TECHNICAL NOTE 1

| Project: Barnesmore Windfarm Repowering – 110kV Grid Connection | Ref: Rev2 |
| Section: 110kV Grid Connection Works Review | Job No: 05-728 |

| Scope of Note: | Review of the 110kV Grid Connection and associated works for the Barnesmore Windfarm Repowering |

Figure 1 - Clogher SS/Golagh Tee Connection Point

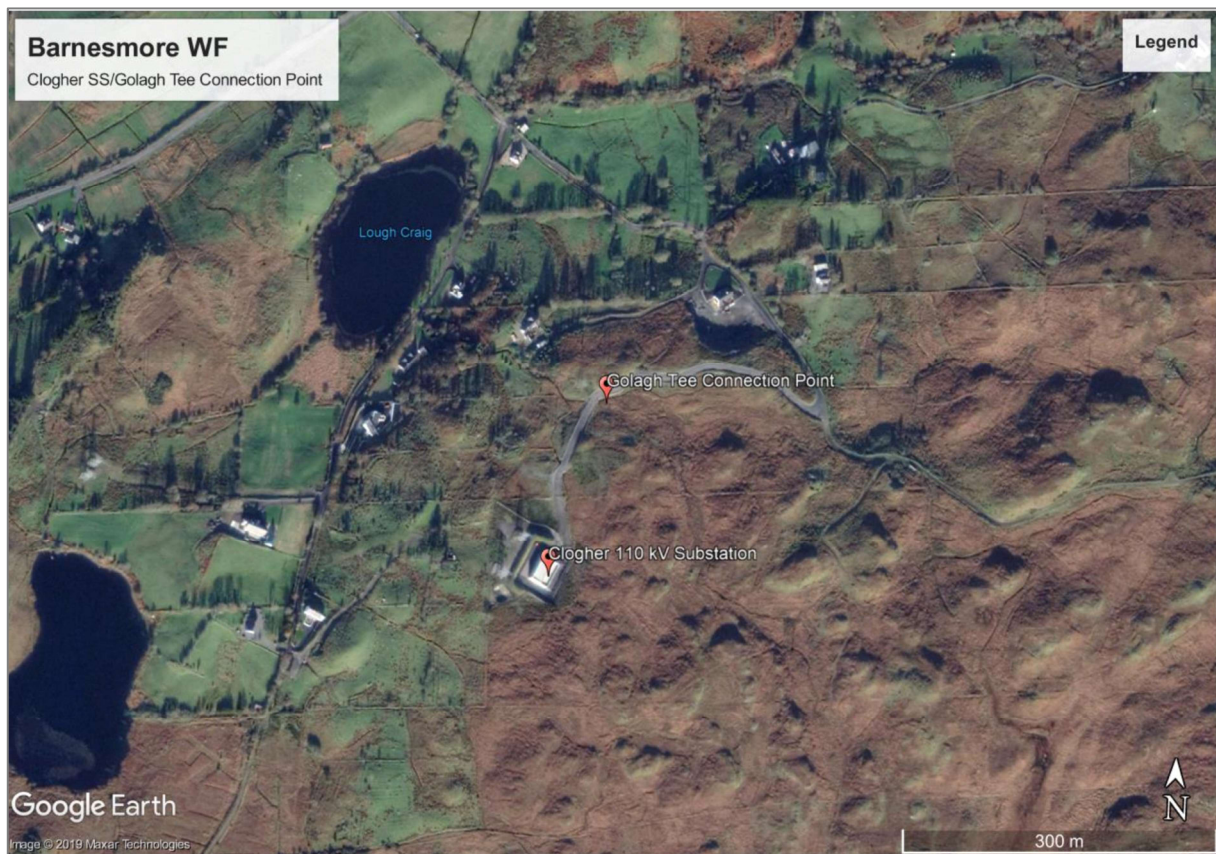
- Construction of a new Cable Interface Tower between Structure 130T and Structure 310
 - New cable interface tower to be built on the east side of the Cathaleen's Fall-Letterkenny 110kV OHL, under the existing Golagh Tee 110kV OHL
- Underground Cable connection from new interface tower to Clogher 110kV GIS Substation (Spare Bay)

- Removal of hard tee-connection between Cathaleen's Fall-Letterkenny 110kV OHL and Cathaleen's Fall-Golagh Tee 110kV OHL.
- Retirement of existing structure 130T
- Termination of existing conductor to new proposed cable interface tower

Figure 2 - Golagh Tee 110kV OHL Undergrounding Works

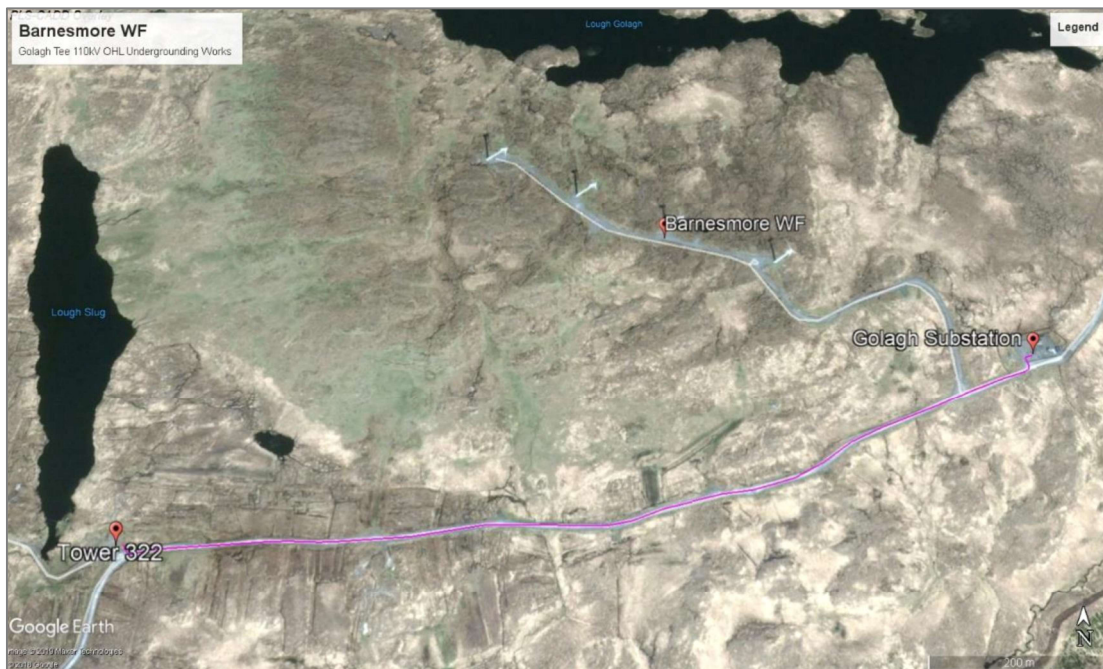
- Construction of a new Cable Interface Tower adjacent to Structure 322
- Installation of new 110kV UGC from new cable interface tower to Golagh SS
 - New UGC is to be installed in the windfarm access road (EirGrid requirement)
- Retirement of existing structure 322
- Termination of existing conductor to new proposed cable interface tower
- Retirement of OHL from new cable interface tower location to Golagh Substation
- Cable termination from new cable interface tower to Golagh Substation
 - Golagh Substation expansion works required as detailed below

Figure 4 - Golagh 110kV Substation – Existing Layout

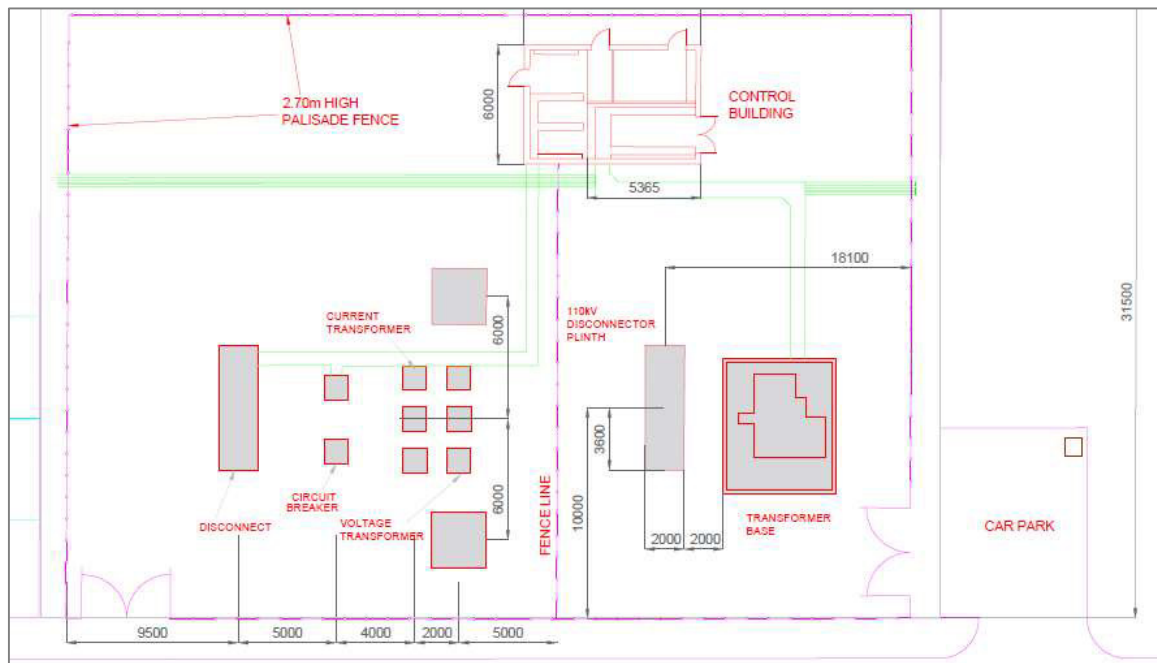
The existing Golagh Substation was designed to meet previous EirGrid Specifications. The new EirGrid 110kV Tail Fed AIS Specification has a number of new requirements not previously required in the older specification. These new requirements will increase to overall substation footprint with considerations to minimise exceeding development boundaries due to the sensitivity of the area. The lands around Barnesmore Windfarm are designated as part of Barnesmore Bog Natural Heritage Area (NHA).

A review of the existing substation design and a comparison to the new EirGrid Specification to identify how the existing substation could be upgraded and expanded to meet the new EirGrid requirements rather than constructing a new substation. The main difference between the existing substation layout and the new EirGrid specification is the requirement for a larger EirGrid control building. The Consultant is proposing that the existing substation compound is extended to the west to facilitate the construction of a new EirGrid control building.

Figure 5 - Golagh 110kV Substation – Proposed New Layout

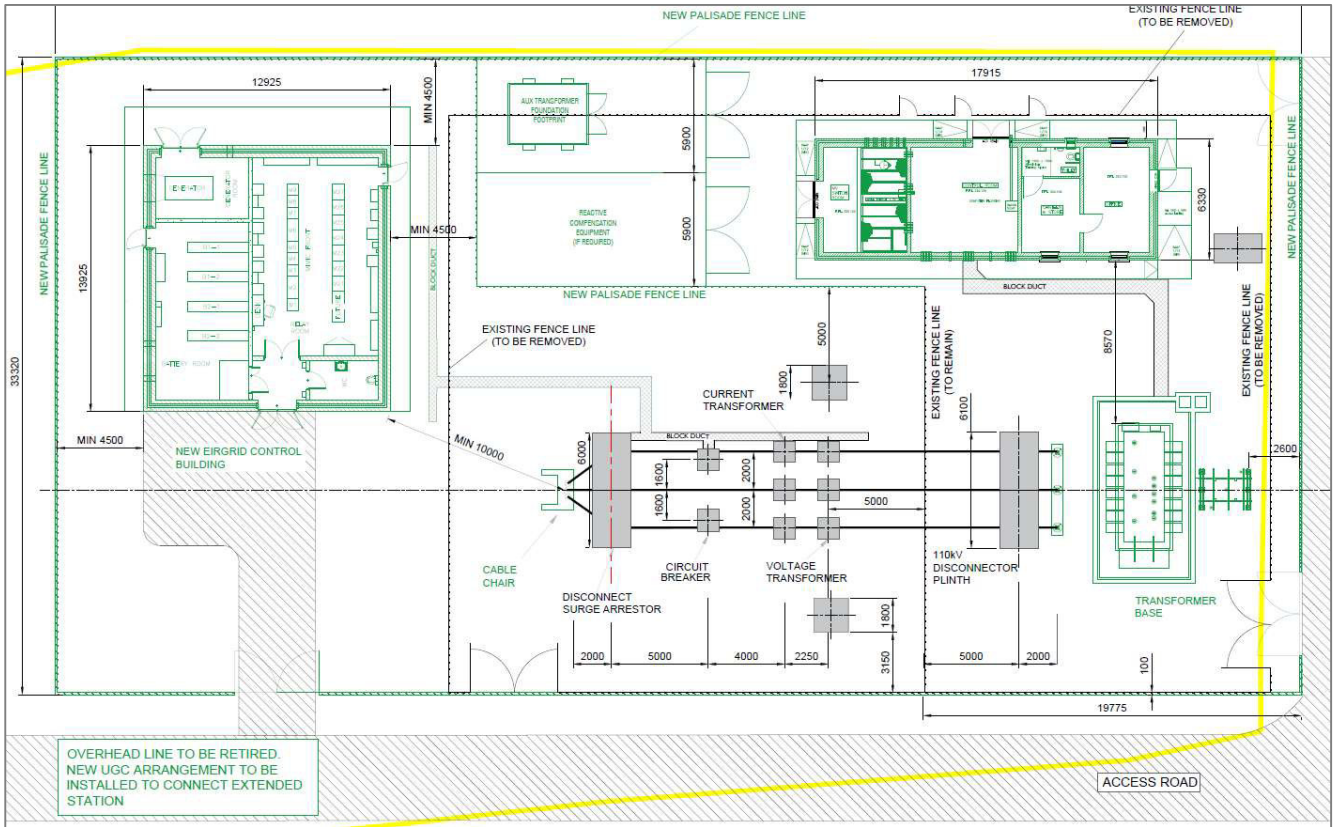
The Consultant is also proposing that the substation compound be extended slightly to the east to facilitate the installation of the larger transformer required for the windfarm. The compound will also need to be extended slightly to the north to facilitate the larger IPP building and Aux Transformer. The Consultant is proposing to maintain the current layout of the 110kV switchgear where possible, however this will need to be confirmed with EirGrid as the current layout varies in some areas to the new specification. It should be noted that some of the 110kV switchgear may need to be upgraded to a higher rating as part of the project works. The proposed 110kV grid connection reconfiguration works and substation expansion works are subject to detailed design.

- Extension of the existing substation compound to the west, north and east
- Installation of a new substation access point on the west side of the substation

- Installation of a second substation access point on the east side of the substation
- Installation of a new substation boundary and perimeter fence
- Construction of a new EirGrid control building as per new specification

- Extension of the existing control building to be used as the IPP control building
- Installation of a larger transformer (incl. transformer bund and plinth)

- Installation of a new Auxiliary Transformer
- Installation of reactive compensation equipment (if required)
- Retirement of the exiting OHL connection
- Installation of a 110kV Cable Chair

- Connection of a new 110kV UGC to the new cable chair
- *Surge arresters at line side are currently located on line disconnect. TBC with EirGrid.*
- *Maintaining use of gantry for over the fence connection. TBC with EirGrid.*

- *Location of transformer disconnect and surge arresters to remain in IPP side of substation. TBC with EirGrid.*
